**Pacific Gas & Electric Company**  
**ELC (Corp ID 39)**  
**Status of Advice Letter 6363E**  
**As of November 30, 2021**

Subject: Modifications to Electric Rule 21 Pursuant to Decision 20-09-035 Ordering Paragraphs 5 and 8

**Advice 6363-E**

**Subject: Modifications to Electric Rule 21 Pursuant to Decision 20-09-035  
Ordering Paragraphs 5 and 8.**

##### I. Screen L: Transmission Dependency, and ~~Transmission~~ Stability, ~~Overvoltage, and Islanding~~ Tests

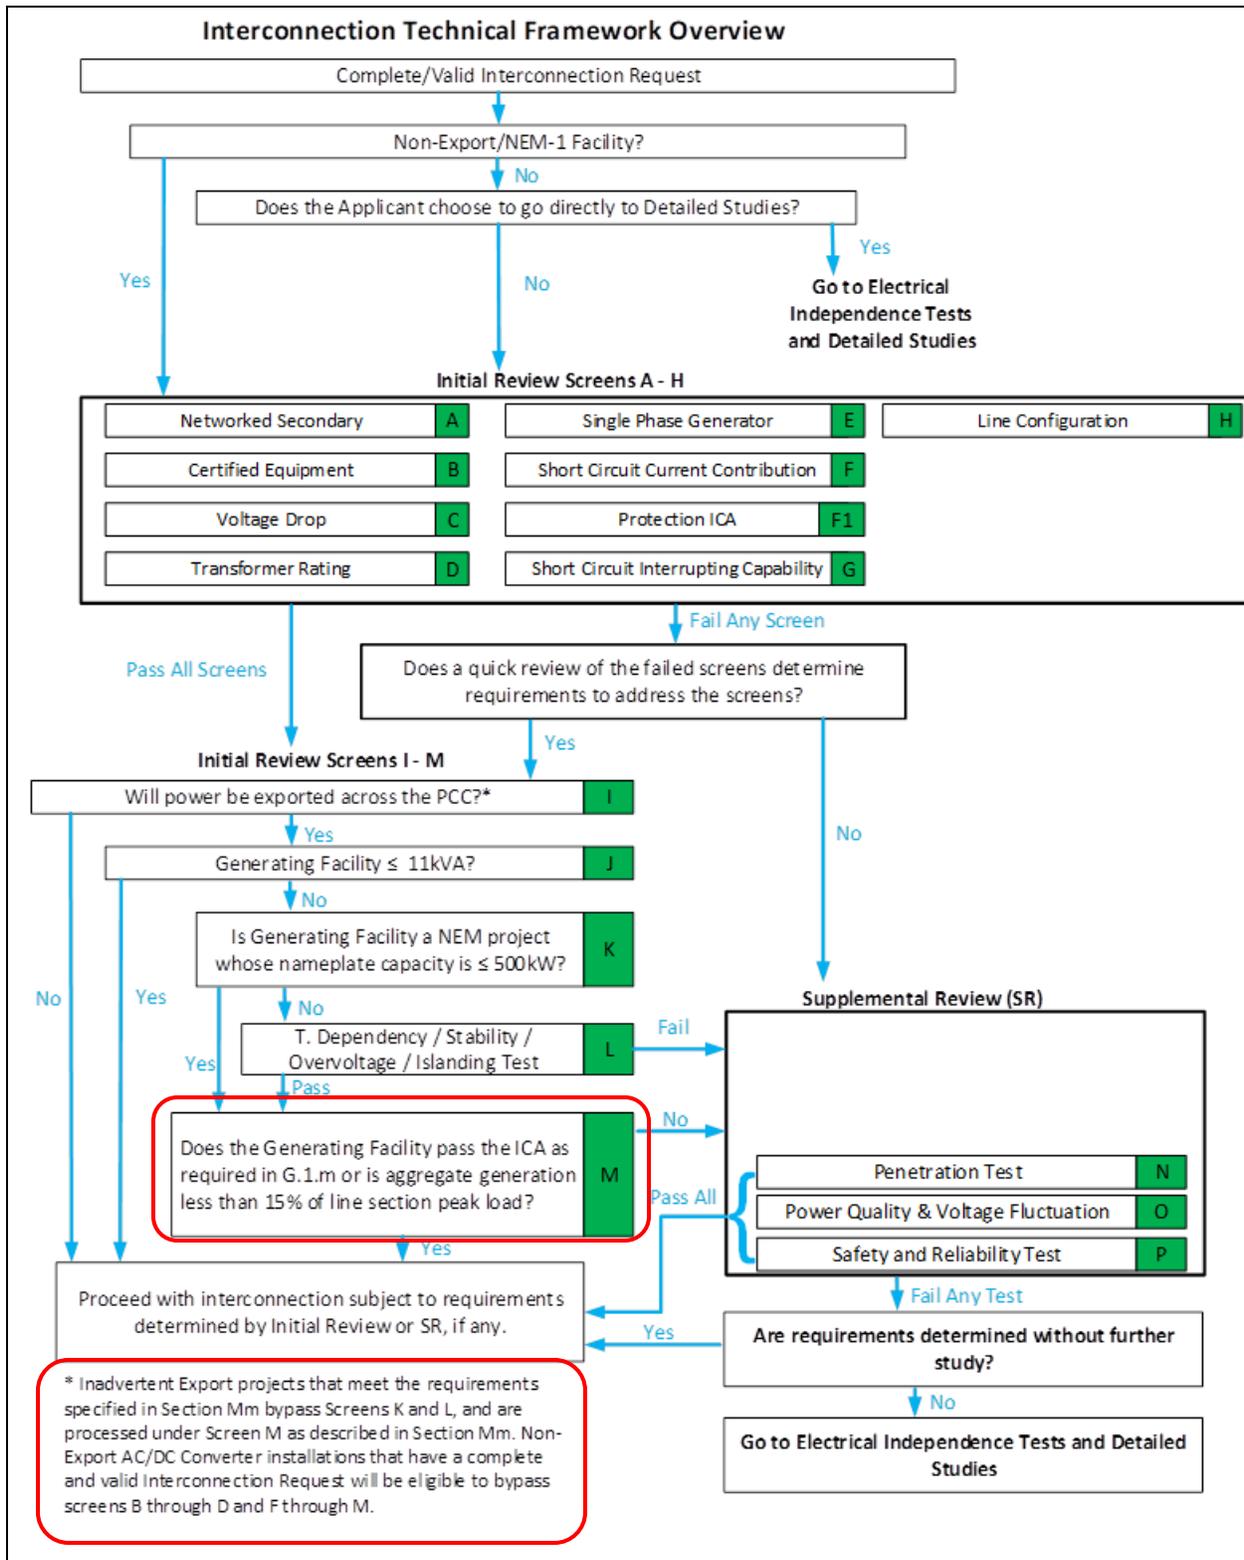
Based on the guidance noted from Energy Division above, PG&E modifies Screen L as shown below.

Is the Interconnection Request for an area where: (i) there are known, or posted, transient/~~dynamic~~ stability limitations, or (ii) the proposed Generating Facility has interdependencies, known to Distribution Provider, with earlier-queued Transmission System interconnection requests, ~~or (iii) islanding conditions are possible based on PG&E's currently adopted and published screening policies with respect to antiislanding, or (iv) transmission ground fault overvoltage is possible based on PG&E's currently adopted and published screening policies with respect to overvoltage screening.~~ Where (i) or (ii) ~~or (iii) or (iv)~~ above are met, the impacts of this Interconnection Request to the Transmission System may require ~~Detailed further~~ Study.

Sheet 145

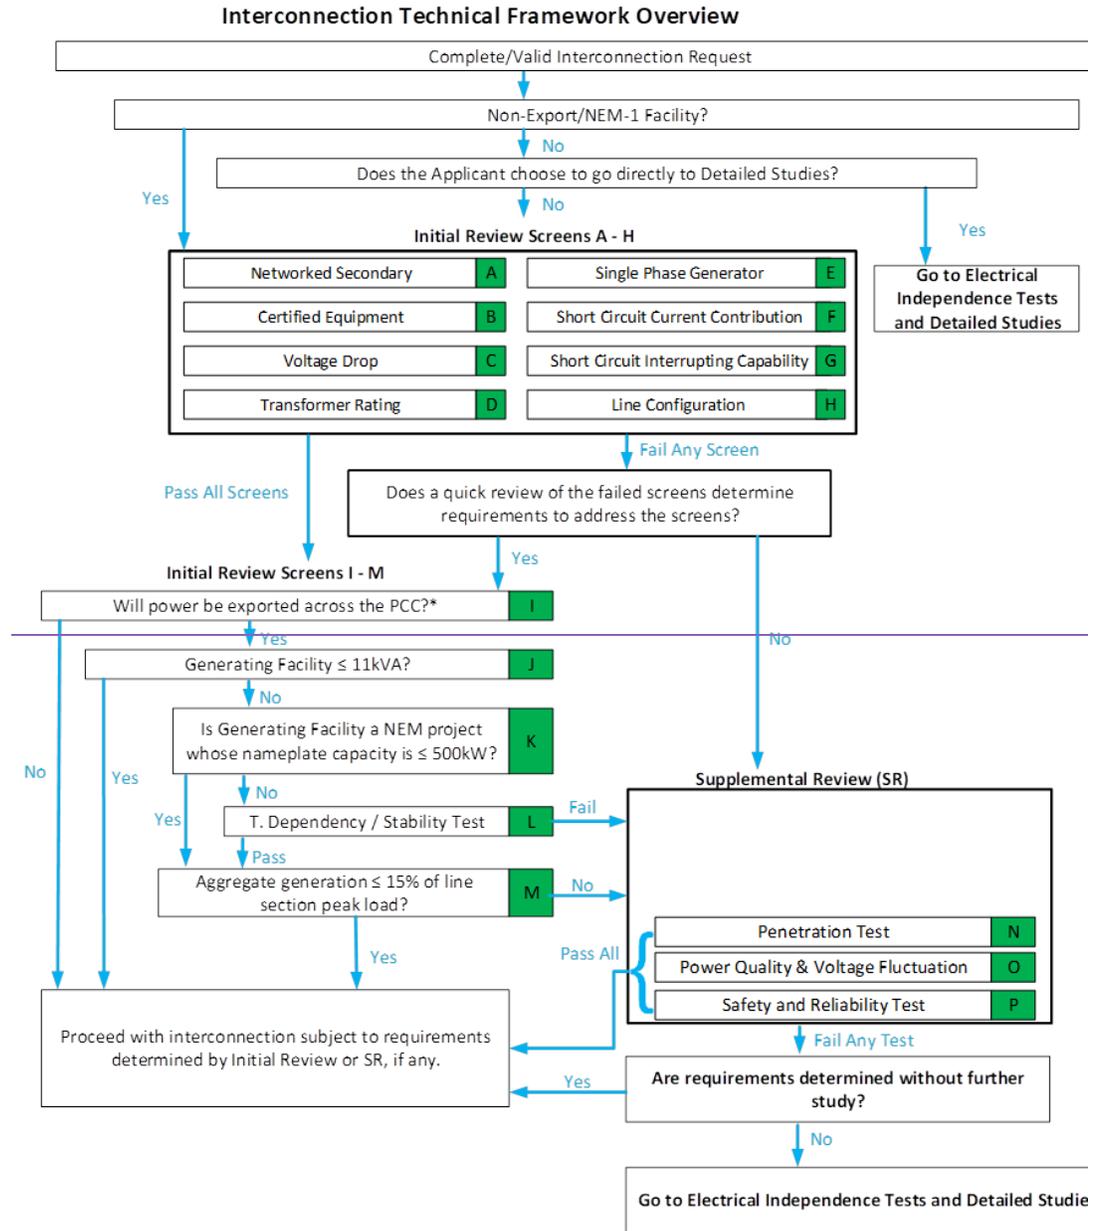
PG&E also makes changes to technical screen flowchart with updates consistent with the changes above. Specifically, PG&E modifies Screen M to be consistent with OP 8 changes above. And for clarity, it combines the two existing footnotes for (\*) and referenced in screen I into a single footnote (\*).

DELETE FLOWCHART BELOW:

ADD FLOWCHART BELOW:
